## Improvement for 240.077 Cable Sleeve for Zoom Head

Here is a solution to improve the strength of the cable sleeve for Zoom Heads (240.077) on first Zoom Heads series.

#### Example of the improved mounting

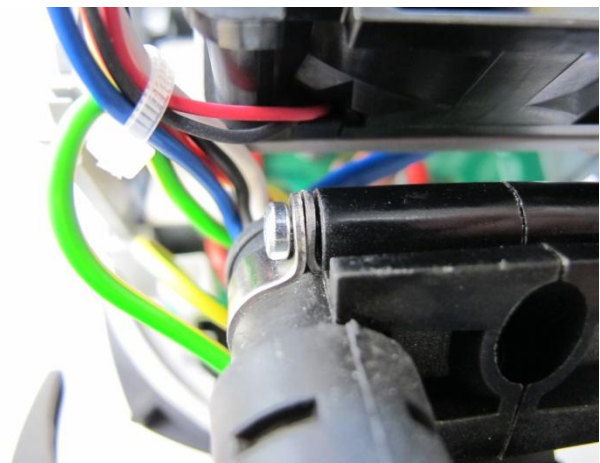
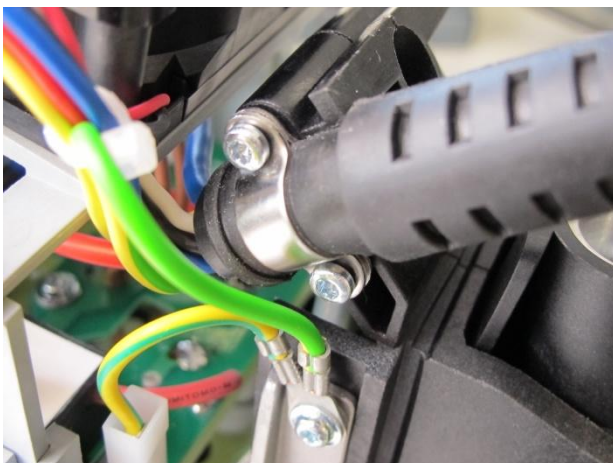
The improvement comprises adding a cable clamp between the cable sleeve and the cable fixture.

To apply the improvement, you need two new screws **211.823** (more longer), one added cable clamp **240.078** and a new cable sleeve **240.077** if the old is damaged.
